Based upon information from the GMD3 model, this proposal will cause minimal effects on neighboring wells, and is unlikely to create an impairment. GMD3 staff recommends approval of the application.

Project: 16495 ID 1

Location: Meade County

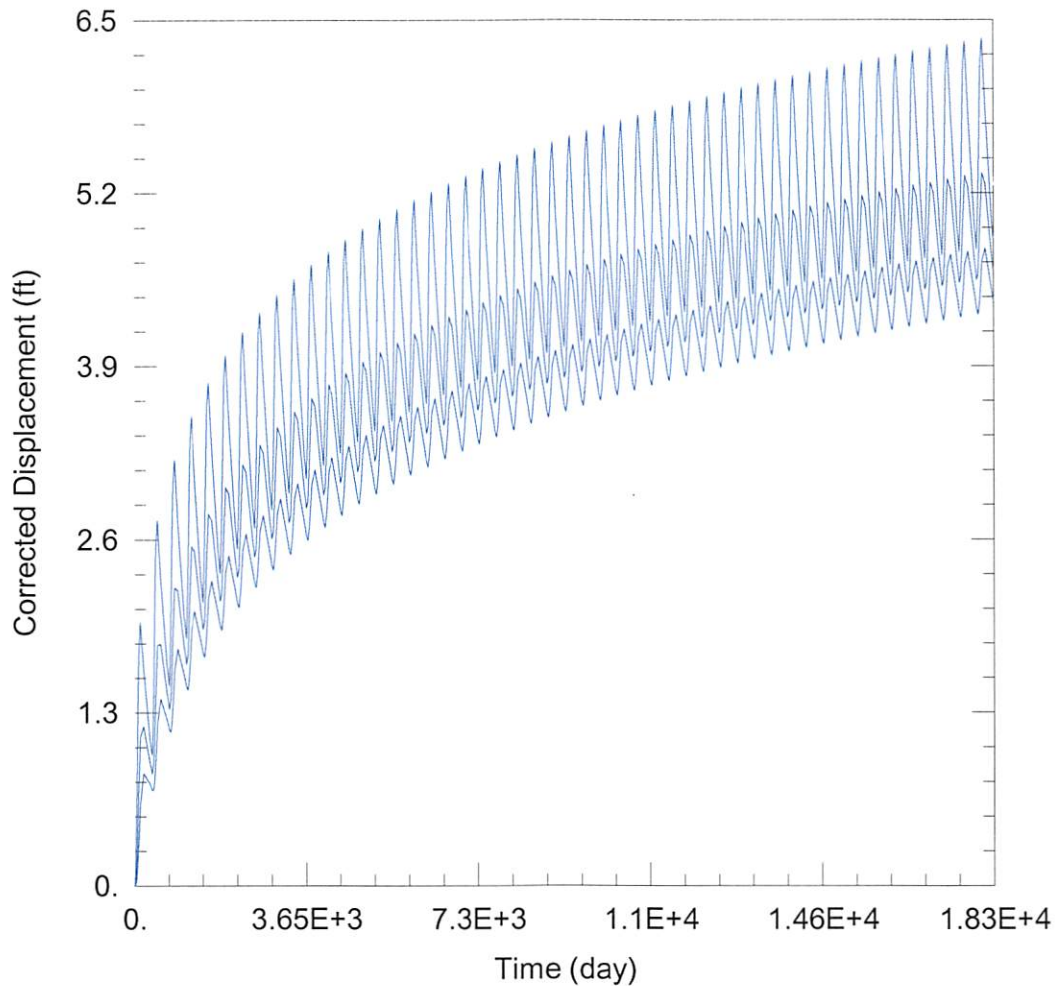
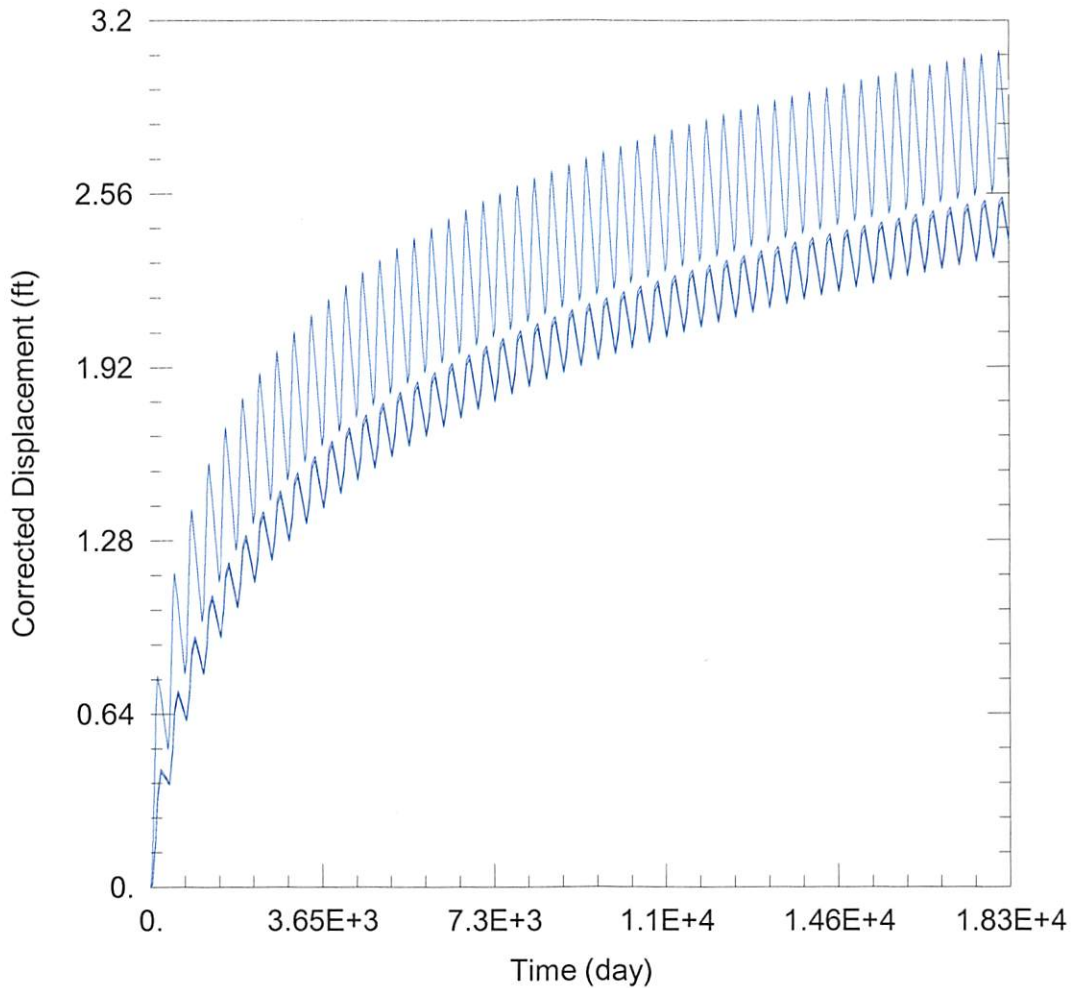
11799 ID 5: Drawdown from current location = 2.52 ft
 Drawdown from proposed location = 4.74 ft
 Net drawdown = 2.2 ft

Net drawdown does not exceed the drawdown allowance of 4.0 ft for any wells within 1 mile of the proposed location. Therefore, critical well analysis is not necessary.
